FINAL DRAINAGE PLAN

LORSON RANCH EAST FILING NO. 2

JUNE 22, 2018
REV. SEPT. 15, 2018

SF-18-019 / EGP 18-002

DEVELOPED CONDITIONS
DRAINAGE PLAN
LORSON RANCH EAST FILING NO. 2

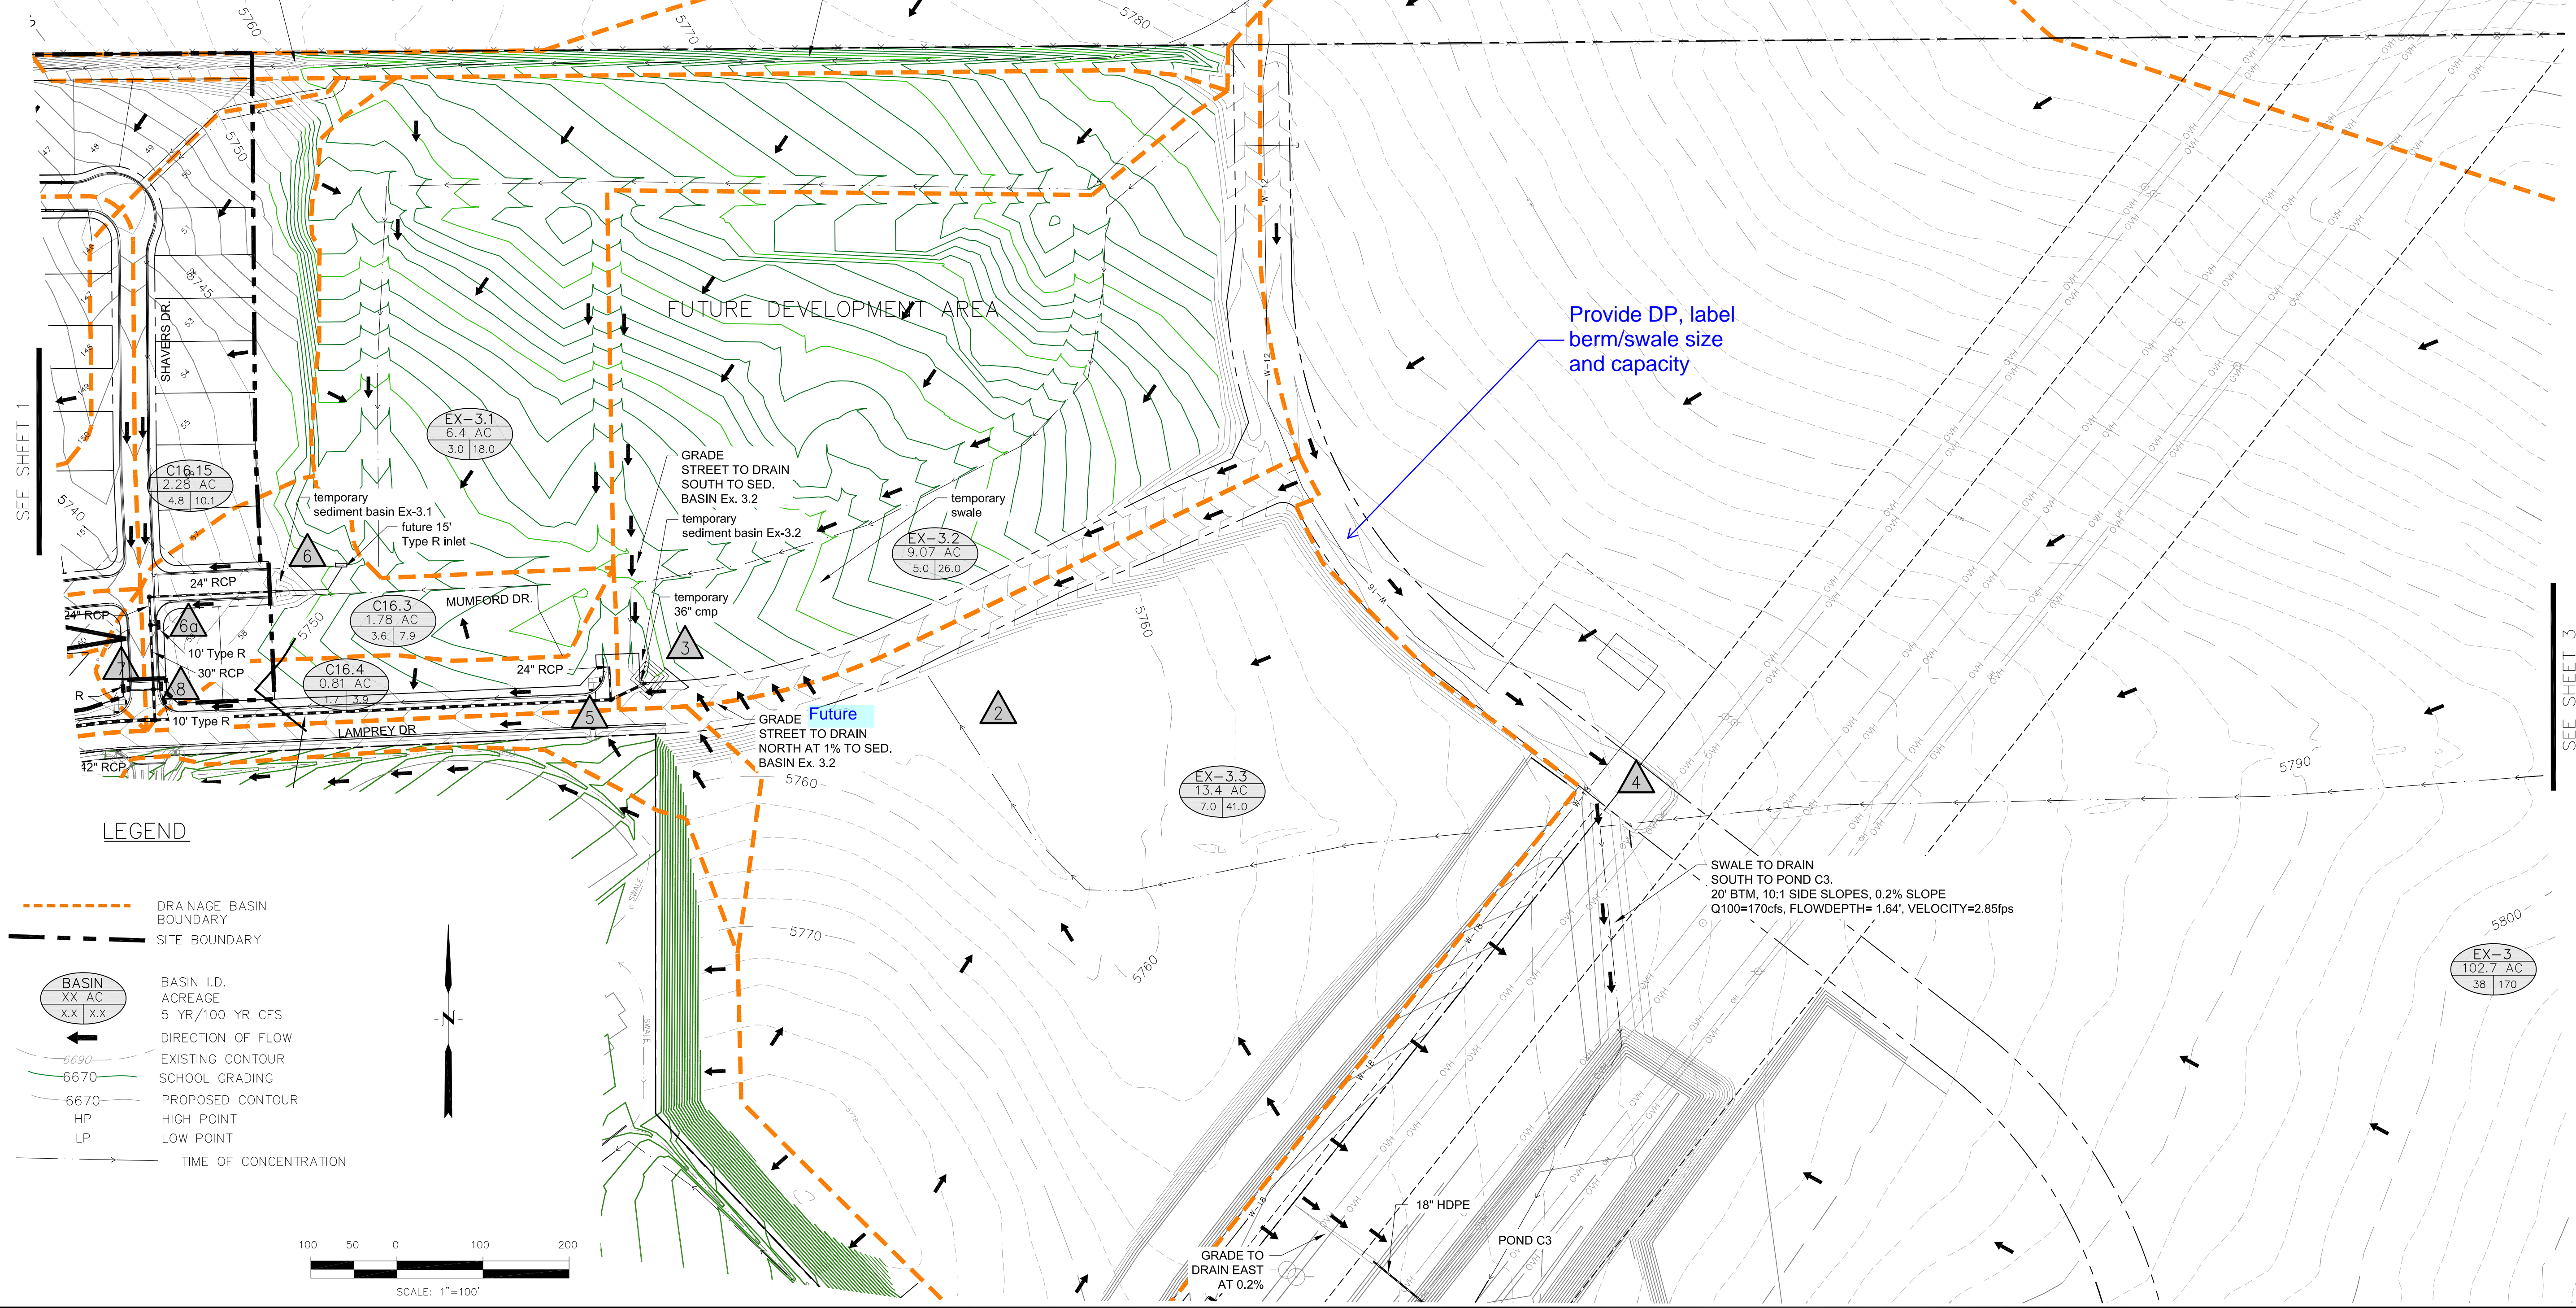
Provide DP, label berm/swale size and capacity

**DEVELOPED CONDITIONS
DRAINAGE PLAN
LORSON RANCH EAST FILING NO. 2**

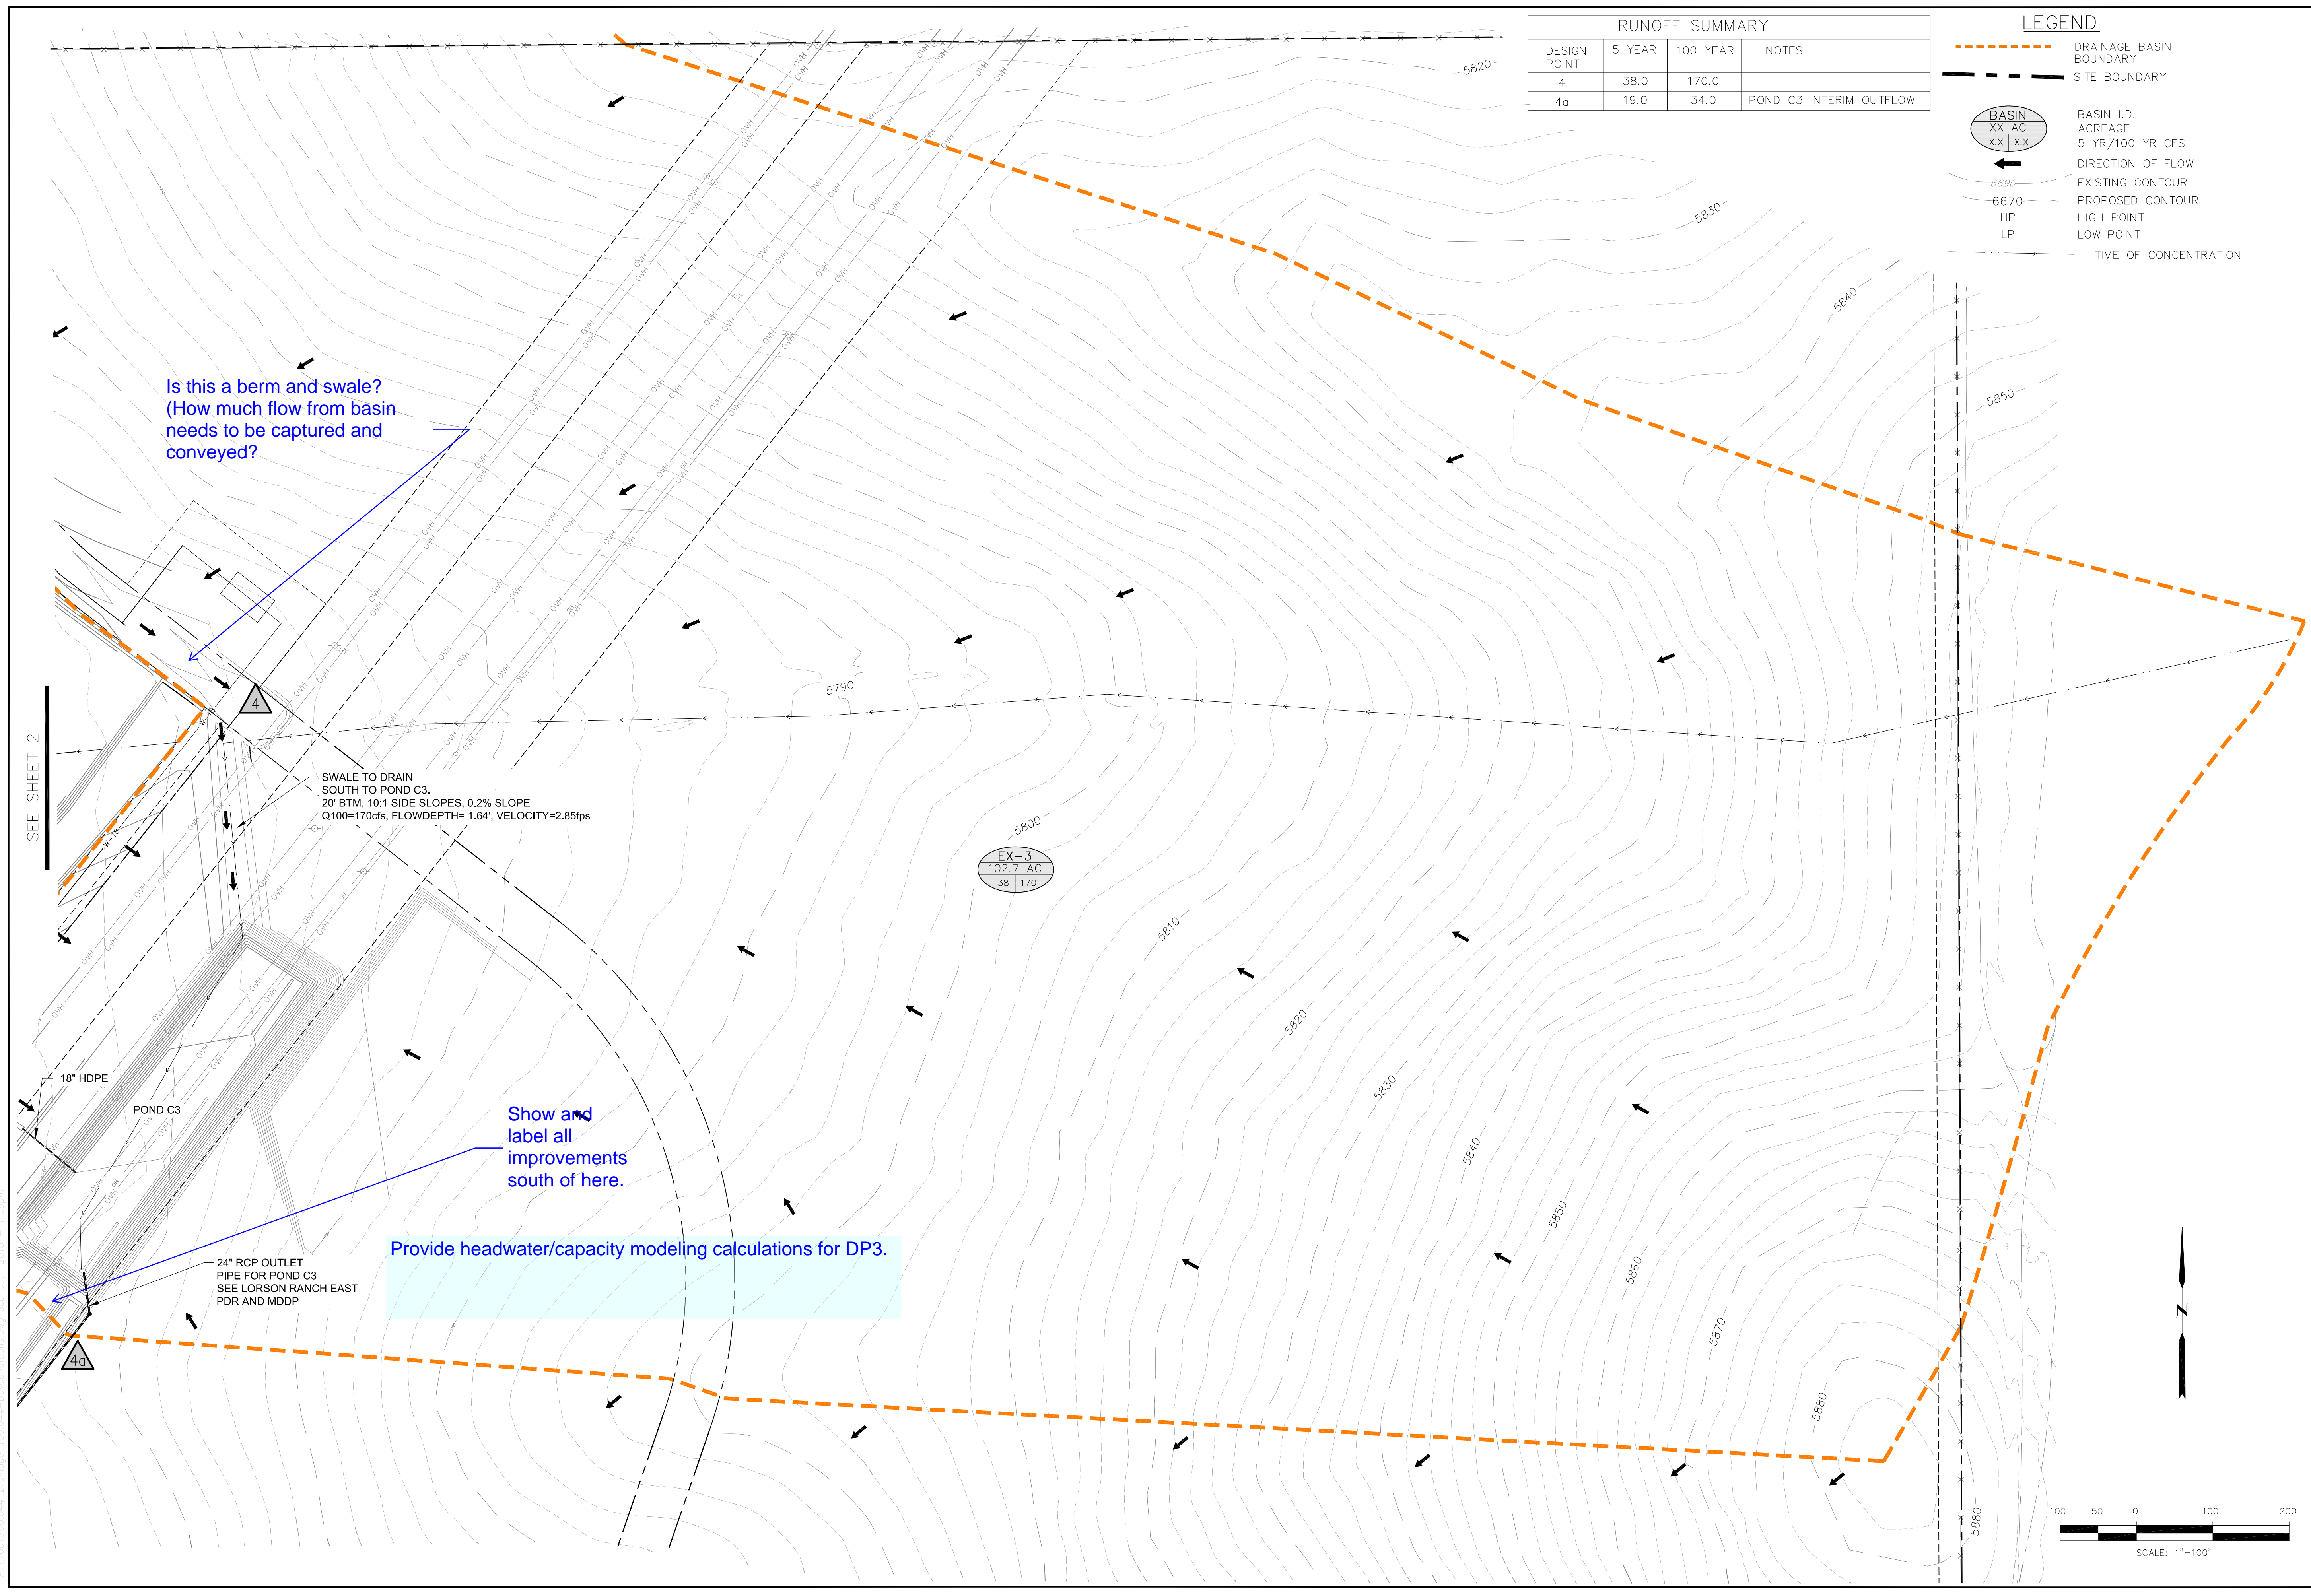
Is this a berm and swale?
(How much flow from basin needs to be captured and conveyed?)

Show and label all improvements south of here.

Provide headwater/capacity modeling calculations for DP3.
